ES_TJA1145A

TJA1145A errata sheet

Rev. 1.0 — 26 March 2026

Figure 1. Illustration of V_{BAT} thresholds and related system controller states

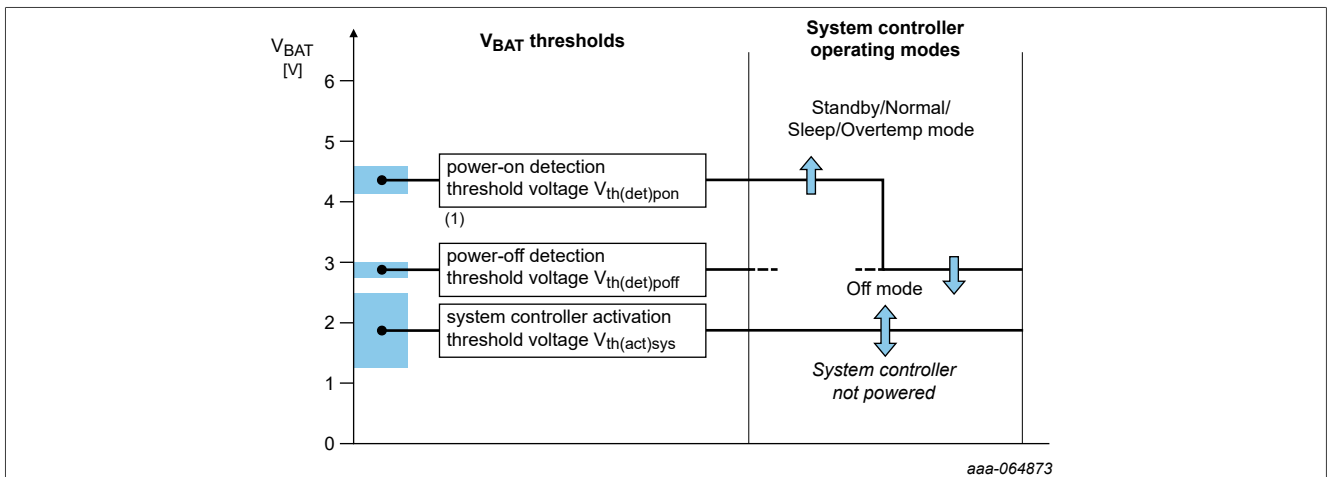
The names of parameters $V_{th(det)pon}$ (power-on detection threshold voltage) and $V_{th(det)poff}$ (power-off detection threshold voltage) may be misleading because here, the terms "power-on/off" primarily refer to the logic state of the device's system controller, which assumes its digital logic is physically powered. A new parameter $V_{th(act)sys}$ (system controller activation threshold voltage) needs to be defined, which represents an additional V_{BAT} threshold below $V_{th(det)poff}$, see [Table 2](#) and [Figure 1](#). The device is physically powered while V_{BAT} (that is, the voltage level at the BAT pin) is above $V_{th(act)sys}$.

In the data sheet, Off mode does not distinguish between physically powered or unpowered state, but such differentiation has turned out to be relevant in the cases described in sections [Section 3.2](#) through [Section 3.4](#).

Symbol	Parameter	Conditions	Min	Typ	Max	Unit
Supply; pin BAT						
$V_{th(act)sys}$	System controller activation threshold voltage		1.2	—	2.5	V

Figure 2. TJA1145A startup behavior with various supply waveform examples for slow or fast ramp-up

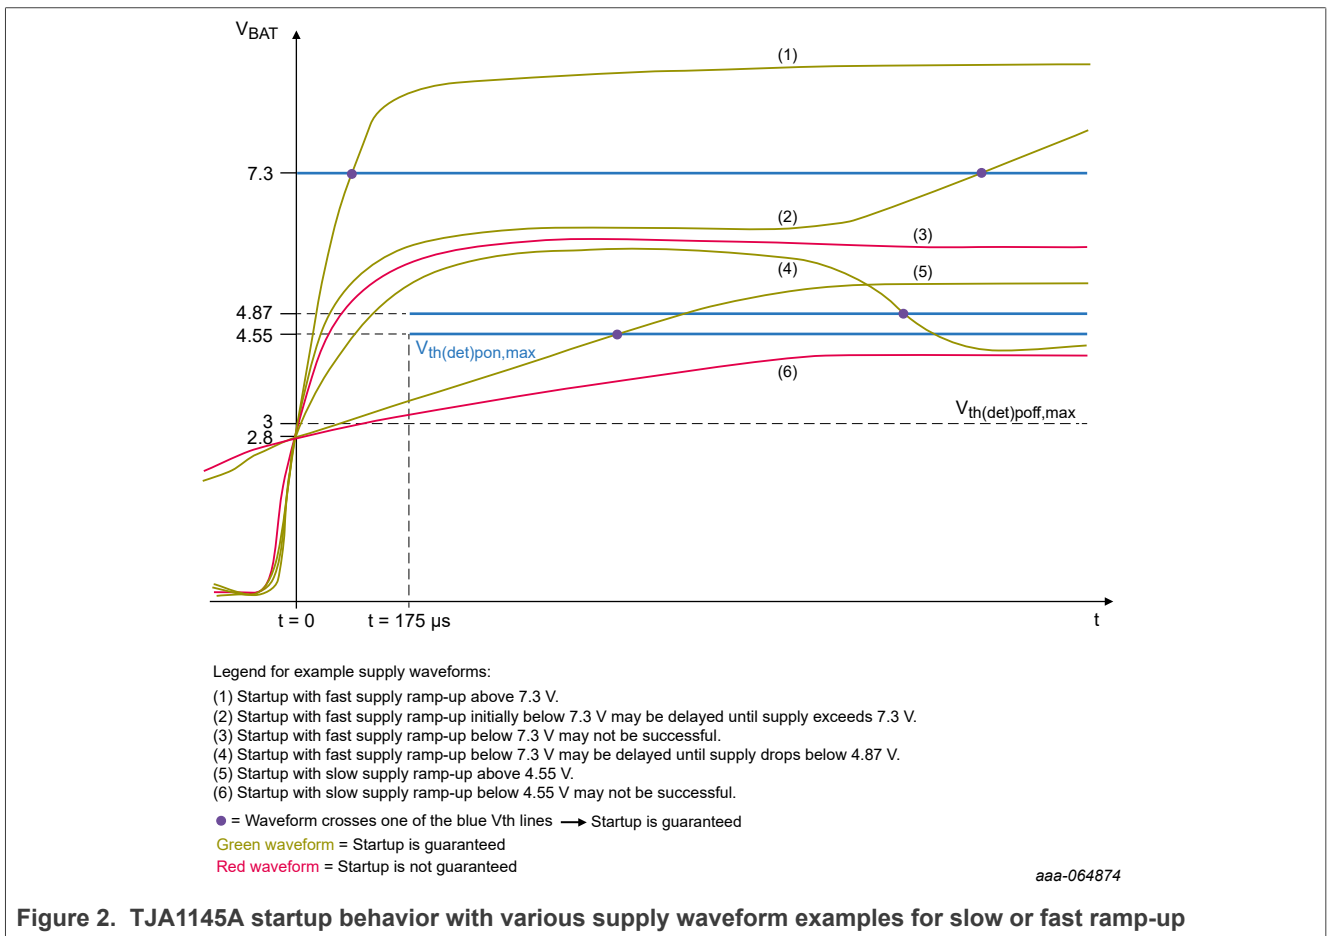
For a "slow" V_{BAT} ramp-up time from 2.8 V to 4.55 V of more than 175 μs, the power-on threshold V_{th(det)pon} dictates the startup behavior, as described in data sheet (see Figure 2). This also applies to any return (with arbitrary slew rate) from a supply undervoltage condition V_{th(act)sys} < V_{BAT} < V_{th(det)poff}.

However, for a "fast" ramp-up time of less than 175 μs, the startup behavior may differ as illustrated in Figure 2:

- Device startup to Standby mode is triggered, at the latest, when the supply voltage exceeds 7.3 V (waveforms 1 and 2 in Figure 2) or has dropped below 4.87 V (waveform 4).
- If, after ramping up, V_{BAT} is kept continuously inside of a small voltage window, specific per sample and within the range 4.87 V to 7.3 V, system controller startup may fail (waveform 3) although V_{BAT} has already risen above V_{th(det)pon}. The device will enter Standby mode only after the system controller has recovered, which will happen when V_{BAT} exits this window (waveforms 2 and 4). Once running, the system controller remains active as expected at least until next power cycle with V_{BAT} falling below V_{th(act)sys}.

Waveforms (1) through (4) in Figure 2 represent examples for fast supply ramp-up, because the rise time from 2.8 V to 4.55 V is less than 175 μs. Waveform (1) can be considered as being typical for connection to a 12 V

car battery by closing a contact. Waveforms (2) through (4) could theoretically occur when closing contact to a discharged, aged and/or overloaded 12 V battery. Waveform (2) assumes battery recovery from initial overload, resulting in delayed but successful startup of the device. Waveform (3) represents a theoretical example without recovery of the battery voltage, which may prevent the device from starting up. Example waveform (4) would initially have the same effect as waveform (3), but it illustrates that device startup will still be triggered when the supply voltage goes down again, latest when it has fallen below 4.87 V.

Waveforms (5) and (6) represent examples for slow supply ramp-up, because the rise time from 2.8 V to 4.55 V is longer than 175 μ s. Waveforms like (5) may occur during cranking of the combustion engine with a weak battery. For completeness, waveform (6) illustrates that startup can obviously not be guaranteed when the supply voltage does not exceed the max value of the power-on detection threshold voltage $V_{th(det)pon}$.

When the BAT pin shall be supplied from a voltage regulator, its output voltage must be higher than 7.3 V.
